Nomad

ALERT SERVICE BULLETIN

STRUCTURE ASSEMBLY — FUSELAGE — REAR — INSPECTION, REPAIR AND INCORPORATION OF MOD N806 (REAR FAIRING STRENGTHENING)

Figure 1 Rear Bulkhead Repair (ASTA Drawing N-03-1019)

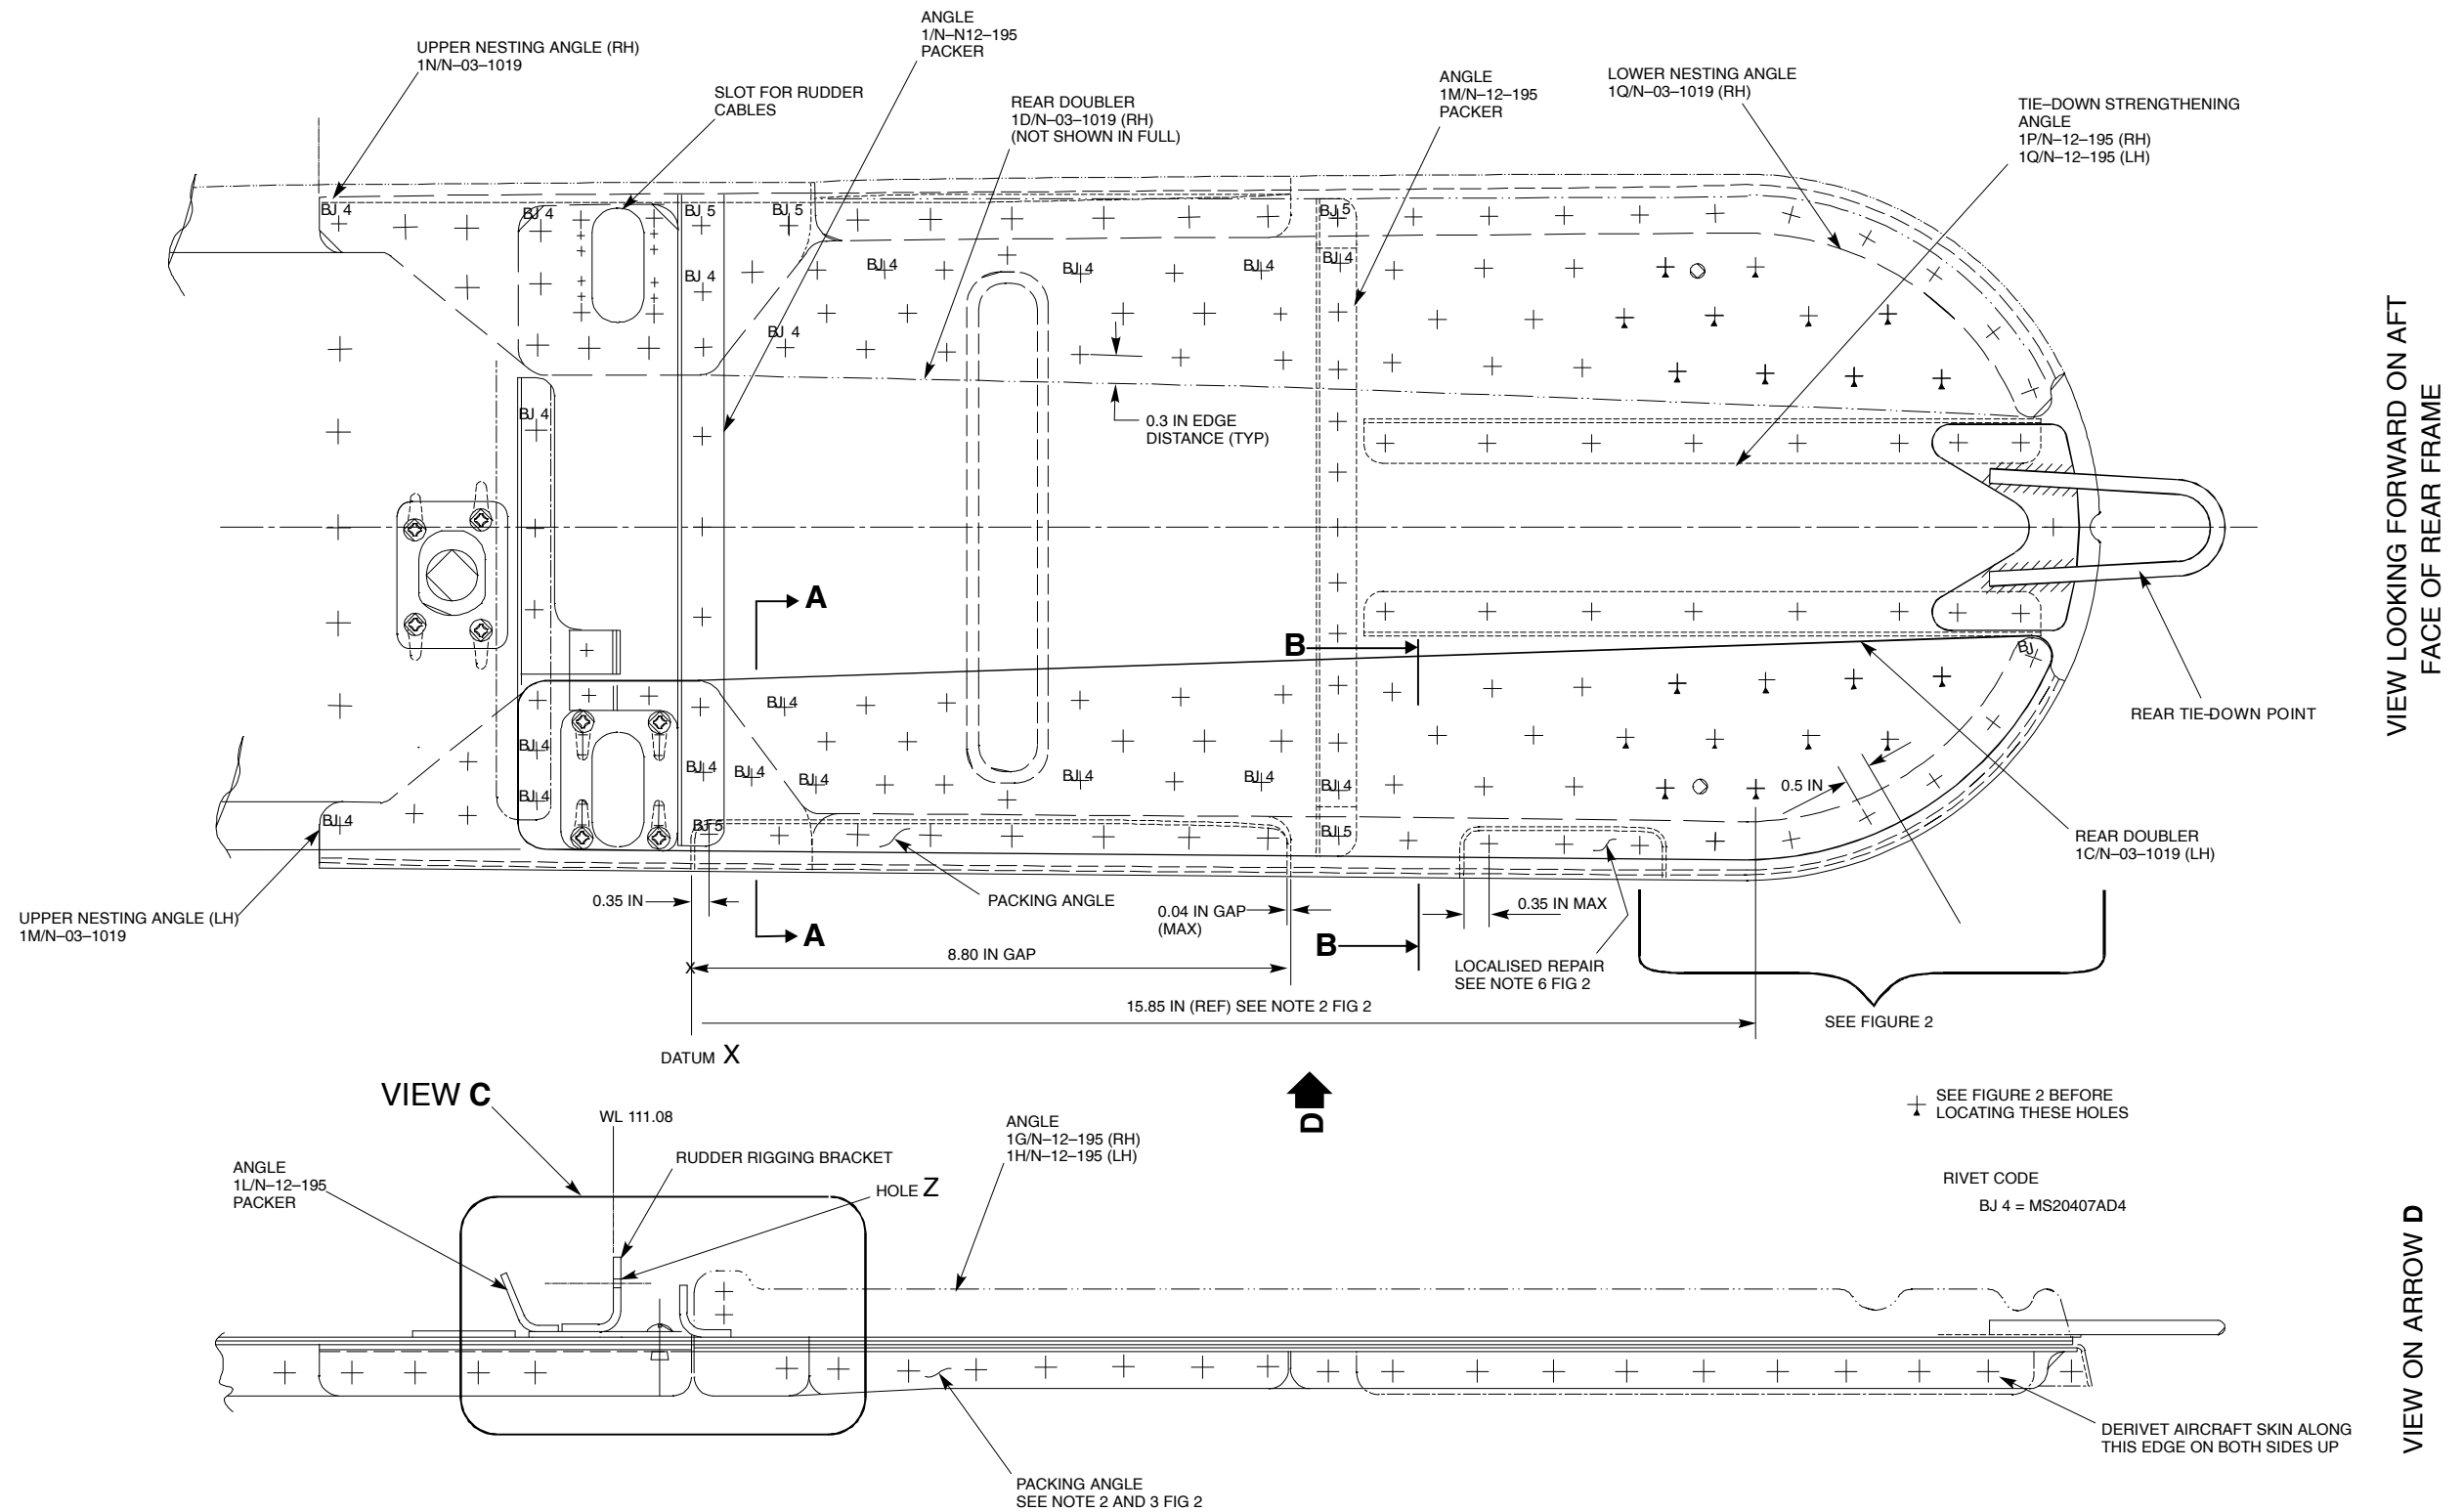
- (3) Cut rear bulkhead and remove damaged and cracked material between Datum 'X' and Datum 'Y' (Ref Figure 1).

- Size the cut-out as required to suit the packing angle PN 1A/N-03-1019 LH and 1B/N-03-1019 RH.
 - Maximum allowable gap between the packing angle and the bulkhead is 0.04 in (Ref Figure 1).

- (6) To repair rear bulkhead between Datum 'X' and Datum 'Y', proceed as follows.
- (a) Position the packing angle PN 1A/N-03-1019 on LH side of the bulkhead as shown in Fig 1.

- (b) Position the packing angle PN 1B/N-03-1019 on RH side of the bulkhead as shown in Fig 1.
 - (c) Position the lower nesting angle PN 1P/N-03-1019 on LH and PN 1Q/N-03-1019 on RH side of the bulkhead as shown in Figure 2 Section B-B.

- (s) Mark remaining rivet holes on the rear doublers according to the pattern shown in Figure 1 and pilot drill using 1/16 in dia drill.
- (t) Pin the doubler plates and upper nesting angles in position and open up 1/16 in pilot holes to 1/8 in.

Figure 2 Rear Bulkhead Repair (ASTA Drawing N-03-1019)

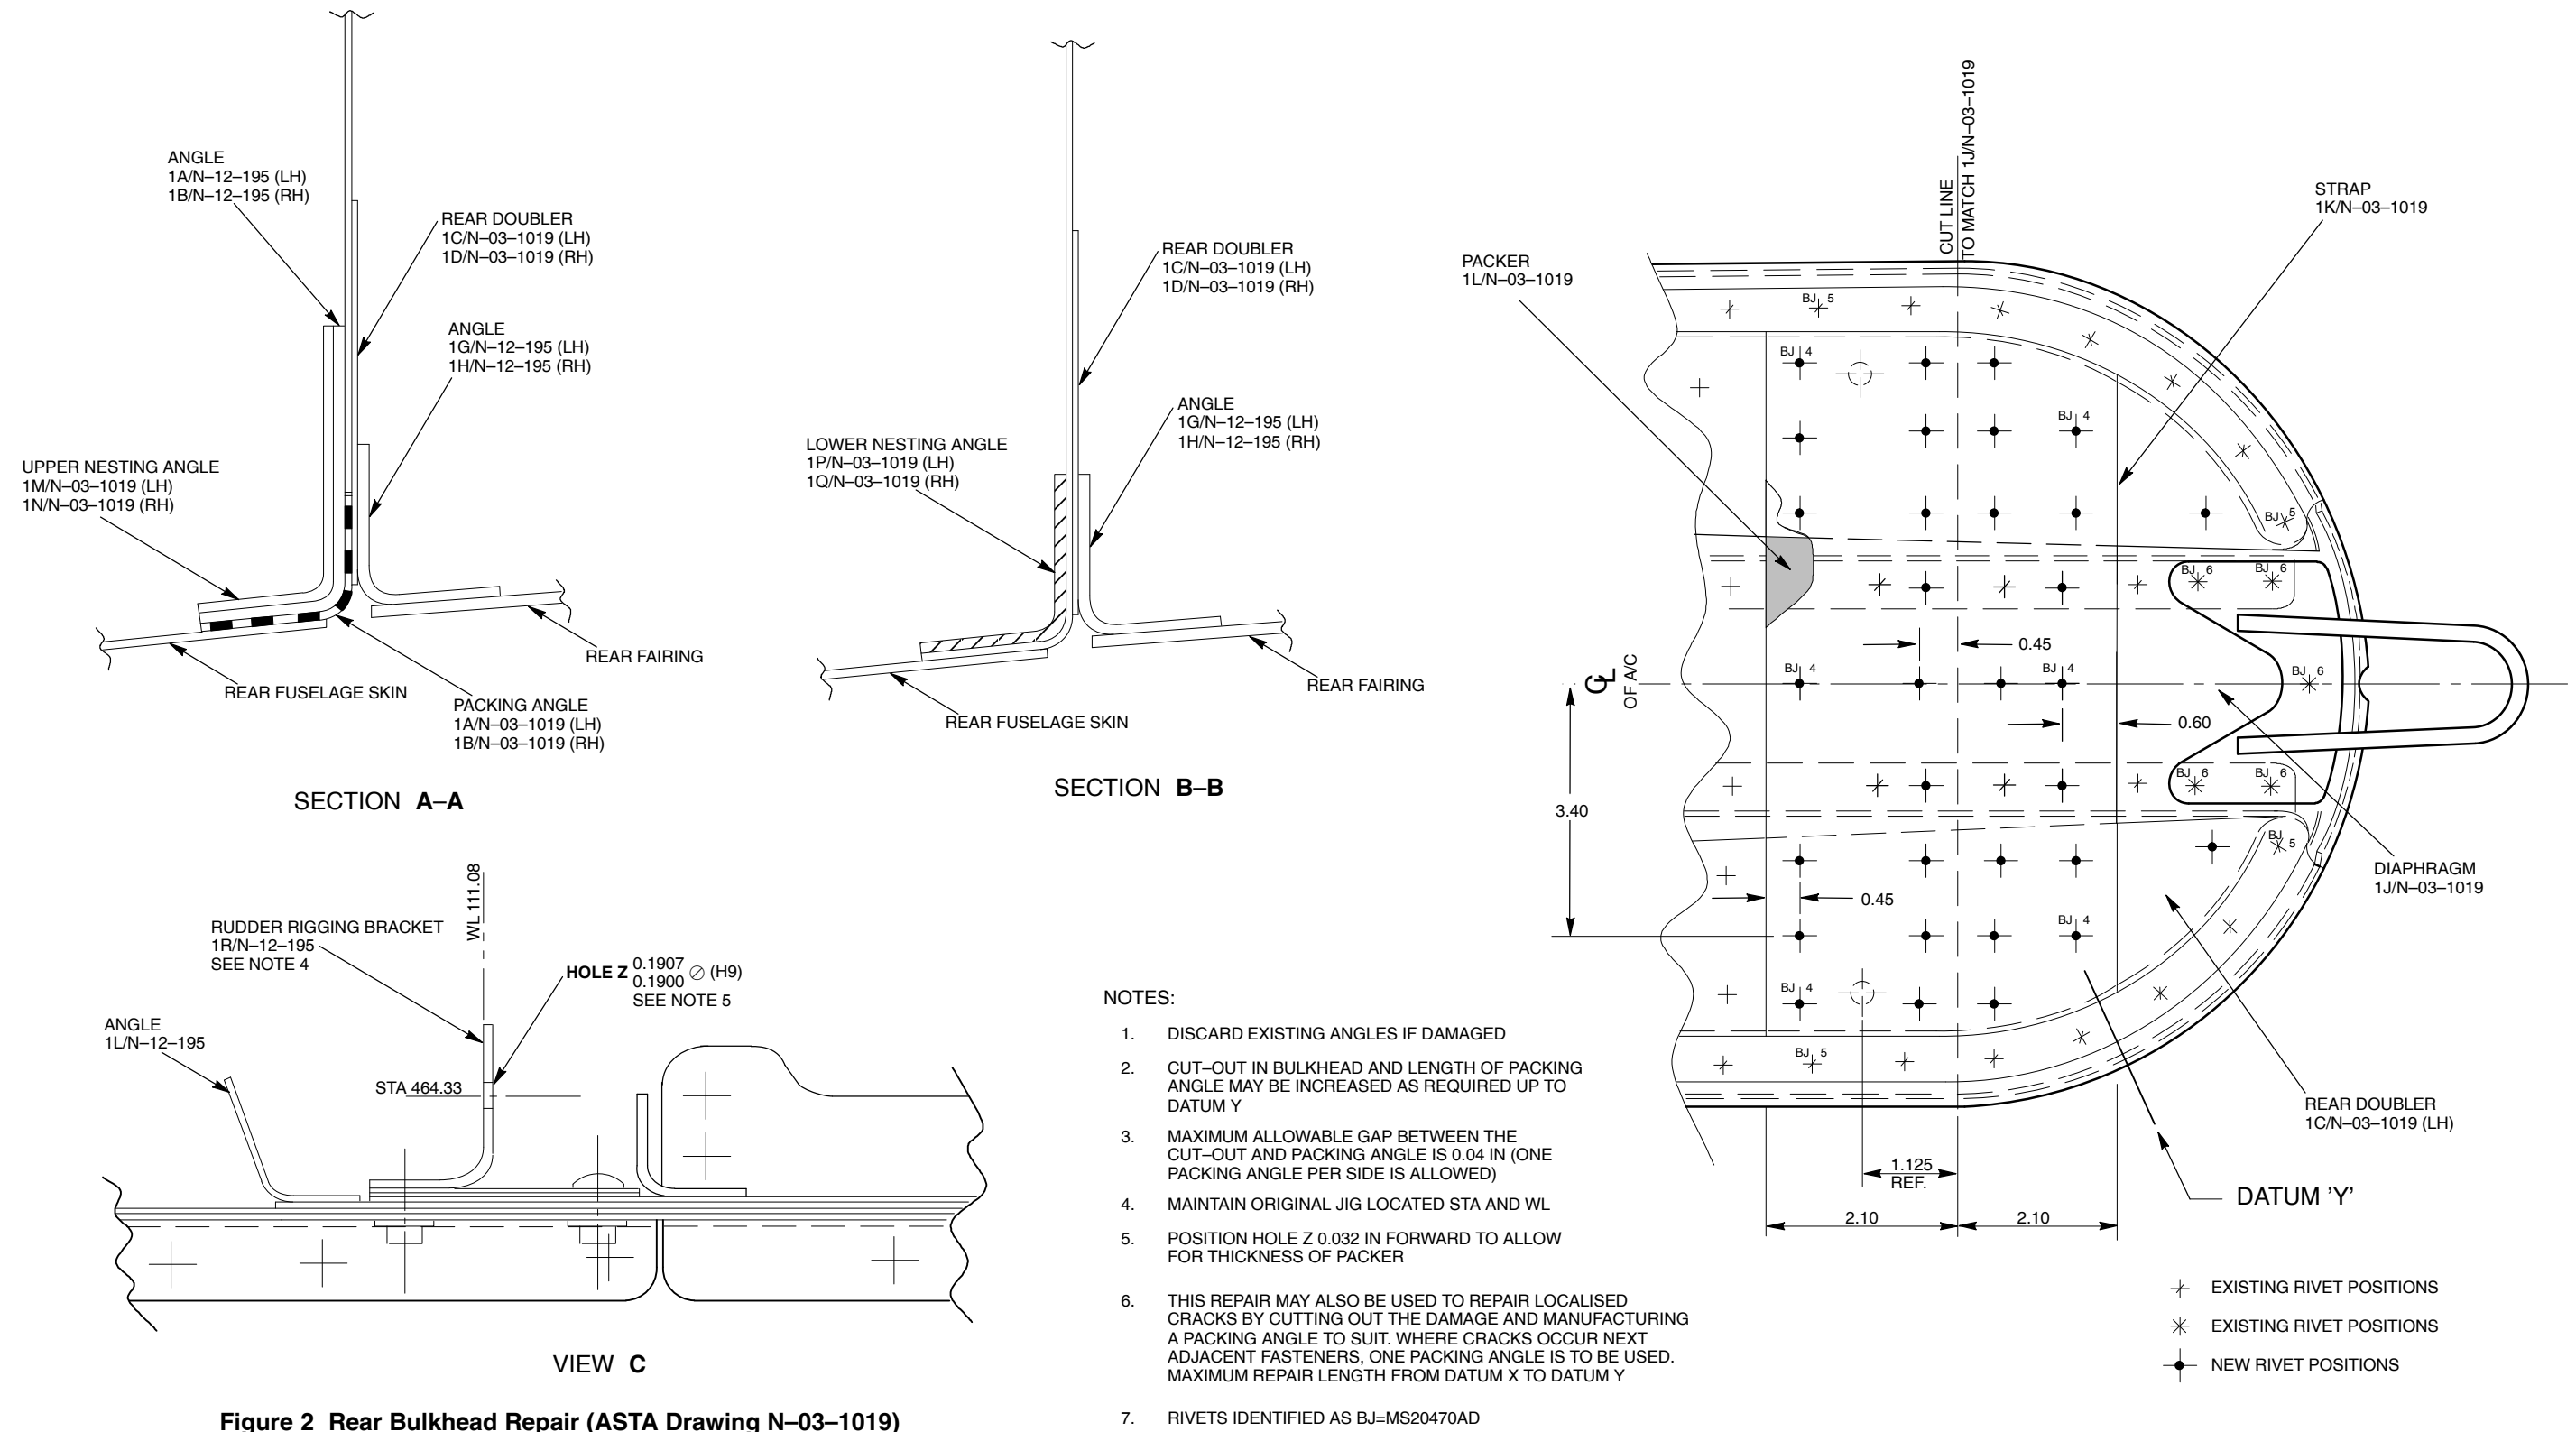
- (b) Cut out the bottom section of the rear bulkhead as shown in Figure 2.
- (5) Deburr the cut-out, remove any sharp edges and apply Alodine (Ref SRM Chap 51-30-00).

- (d) Position the upper nesting angle PN 1M/N-03-1019 on LH and the upper nesting angle PN 1N/N-03-1019 on RH side of the bulkhead as shown in Figure 2 Section A-A.

- (a) Position the diaphragm PN 1J/N-03-1019 as shown in Figure 2, drill rivet holes and skin pin progressively.
 - (b) Mark and pilot drill new rivet positions on the strap PN 1K/N-03-1019 using 1/16 in drill (Ref Figure 2).

- (c) Position the strap PN 1K/N-03-1019 along with packer PN 1L/N-03-1019 as shown in Figure 2 and pilot drill several holes through packer and the diaphragm to clamp parts in place.

Figure 3 Angle, Doubler and Cover Strip Assembly Details

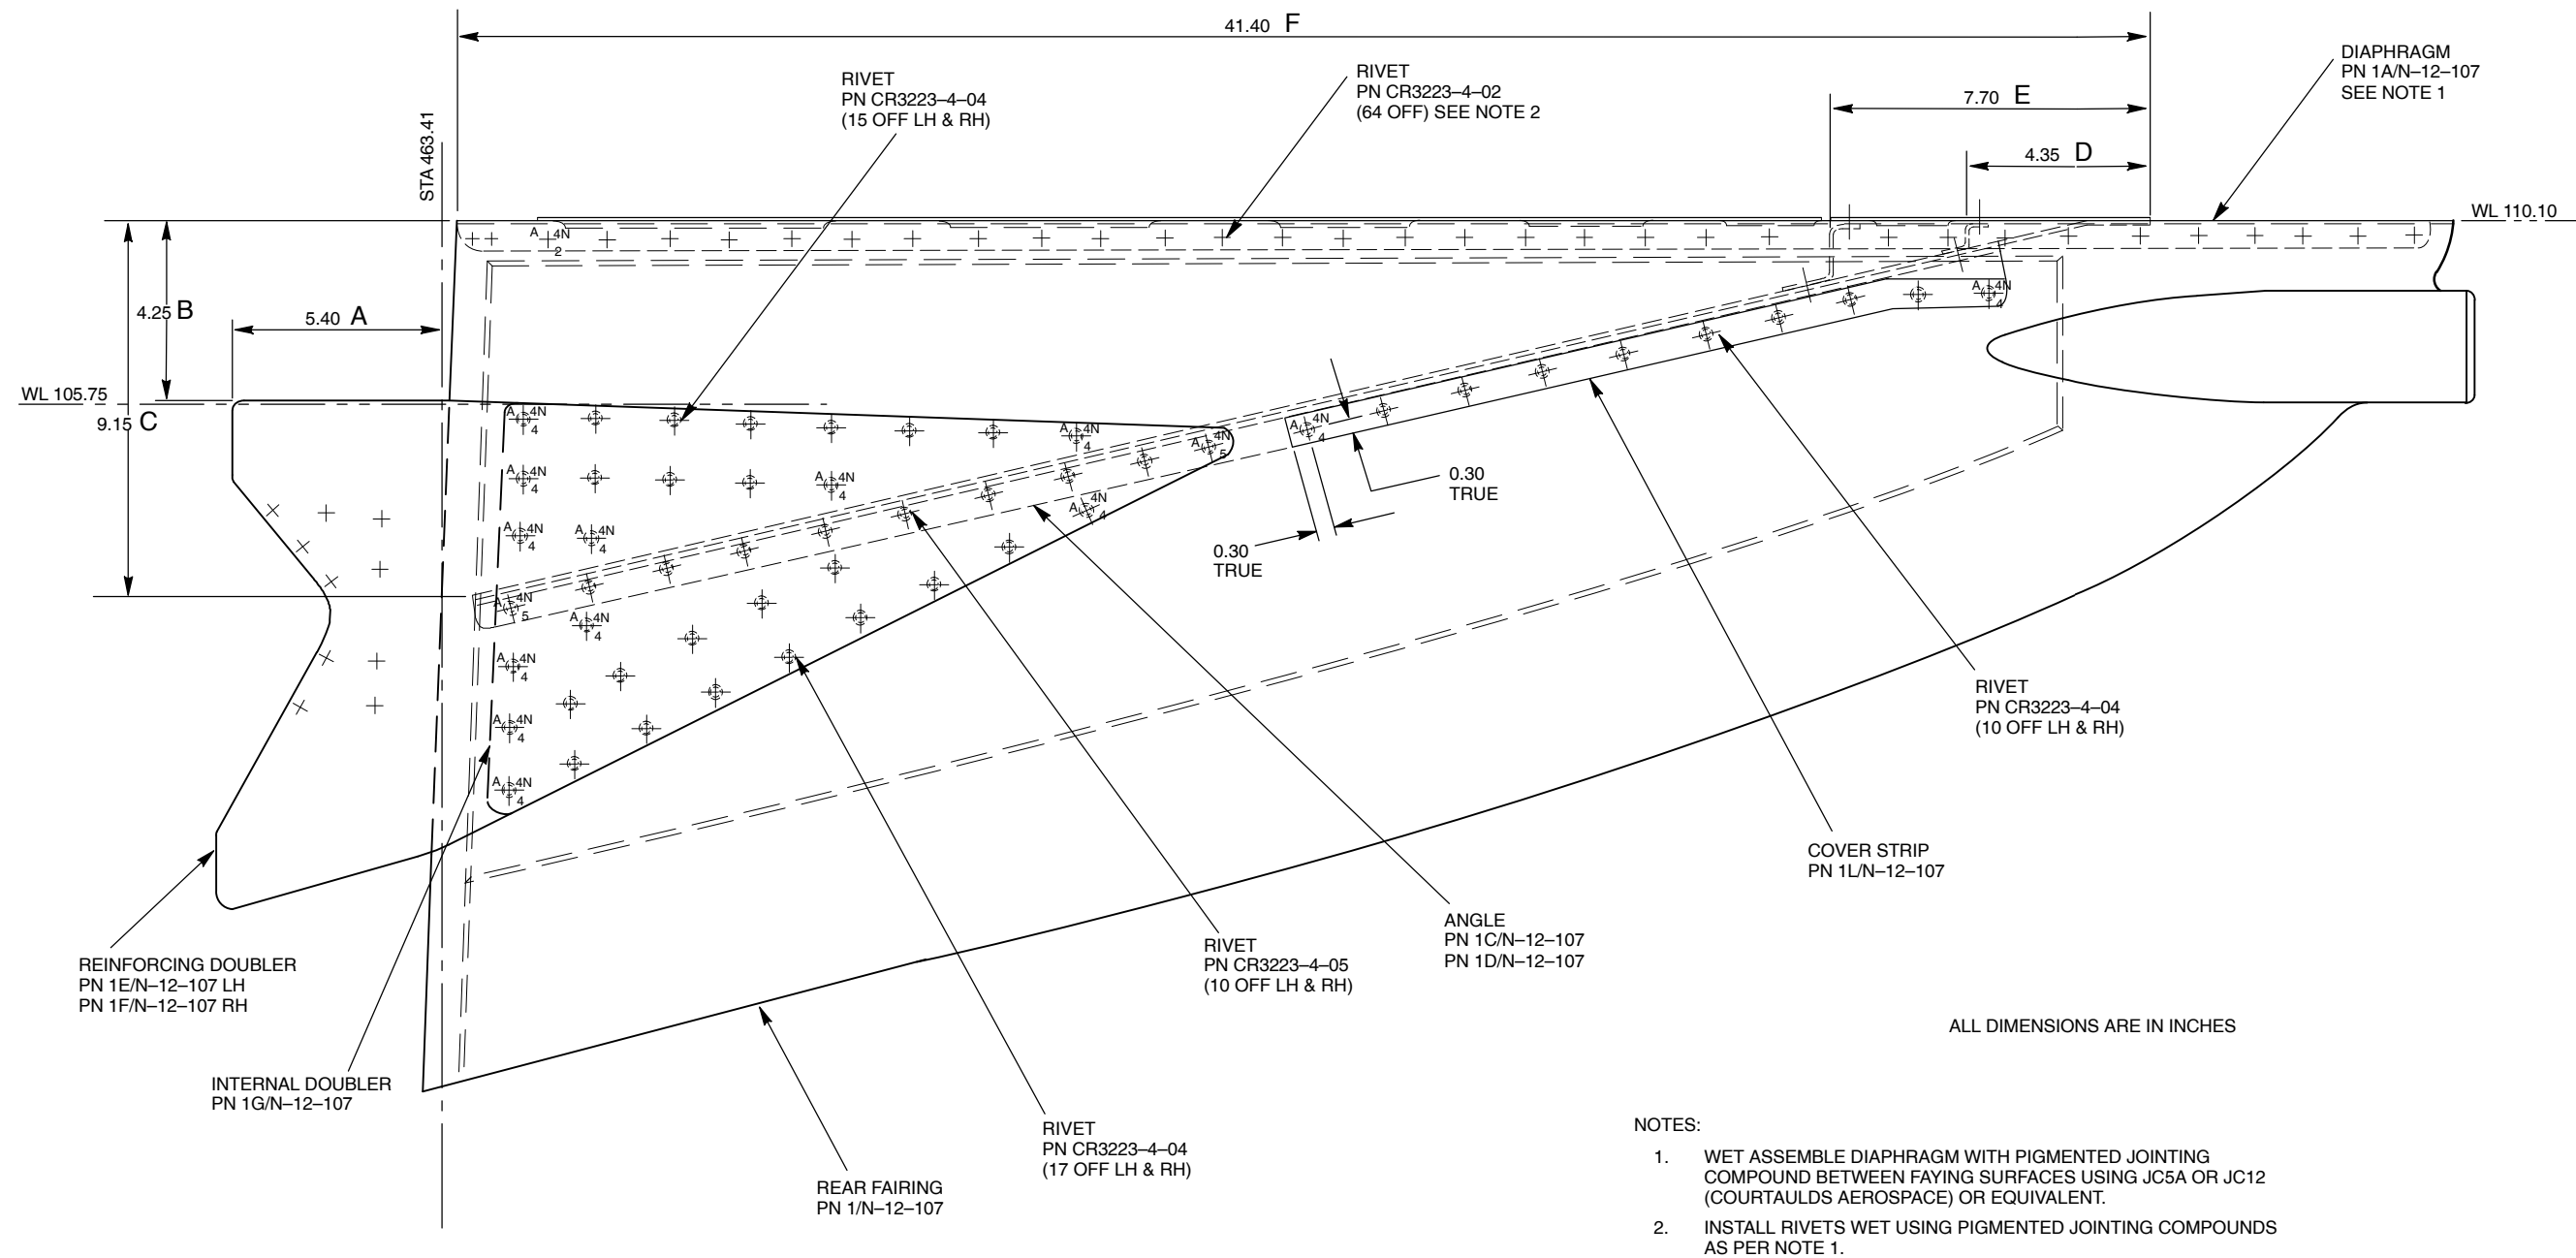
- (11) Position 'zee' Angles PN 1J/N-12-107 and PN 1H/N-12-107 on Web PN 1B/N-12-107. Ensure the top and bottom faces of 'Zee' angles mate with the web and top diaphragm respectively (Ref Figure 3 and Figure 6), clamp and mark position.

- (32) Pin rear fairing to aircraft.
- (33) Place the reinforcing doubler PN 1E/N-12-107 over the LHS of rear fuselage and fairing as shown in Figure 3 and trace the outline onto the rear fuselage skin and rear fairing. Remove and check that all rivets 'A' in Figure 7, and all holes in the fairing within the traced outline have at least 0.30 inch edge distance to the traced outline. If not, reposition and retrace until this is satisfied. If it cannot be satisfied at both ends, ensure that rivets 'A' all have edge distance and trim the aft end of the reinforcing plate to miss the aft most hole. Trim internal doubler 1G/N-12-107 to match.

- (41) Clamp Cover Strips PN 1L/N-12-107 (Ref Figure 3) to Angle PN 1C/N-12-107 ensuring there is sufficient edge distance at both ends. Backdrill through angle, remove and deburr.

- (42) Skin pin internal doublers and reinforcing doublers to rear fairing. Rivet up using Cherrymax rivets PN CR3223-4-04 (Ref Figure 3). Install rivets wet.
